Products affected

Truck			Bus			Power Solutions			
4	PGRT	LPGRS	4	FKN	CK	P93	P96	E2011	PS2024
-	-	-	-	-	X	-	-	-	-

Background

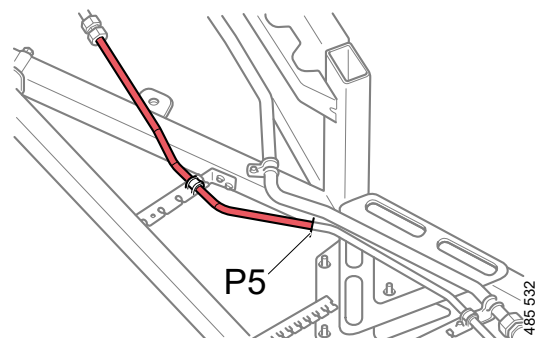
1. Drain the fluid from the hydraulic control system.
2. Disconnect the pipe to be replaced.
3. If pipe 2 758 833 exists, it must be removed and scrapped.
4. Modify the new pipe 2 758 834 by cutting it at the P5 mark as illustrated. The colored part is scrapped

5. Use a new ferrule 1 720 373 and union nut 1 721 741 to complete the pipe.
6. Reconnect the unmodified end of the pipe to the same pipe as before, tighten by 80 ± 12 Nm.

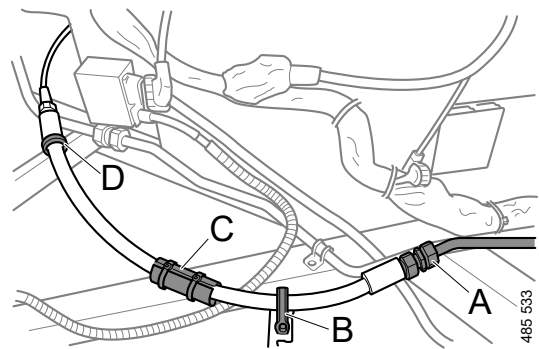
7. Reconnect the modified pipe end to hydraulic hose 3 055 145 [Pos A], tighten by 80 ± 12 Nm.
8. Routing and clamping of pipe 3 055 145 should look like shown in the illustration below. Apart from the clamping points, it should not touch any surrounding parts. If this is already the case, the rest of this instruction can be skipped. Otherwise, proceed as follows.

9. Ensure that the clamping is done as below. Tightening torque 6 ± 1 Nm for clamping screws.
 - a. Use clamp 813 940 and bracket 812 609 to attach the rear end of the hose (Pos B).

- b. Use protection 1 314 199 with 2 cable ties 815 363 (or similar) around the hose where it touches the frame (Pos C).
 - c. Fit clamp 813 940 to secure the hose to the location where pipe 2 758 834 was previously attached (Pos D).
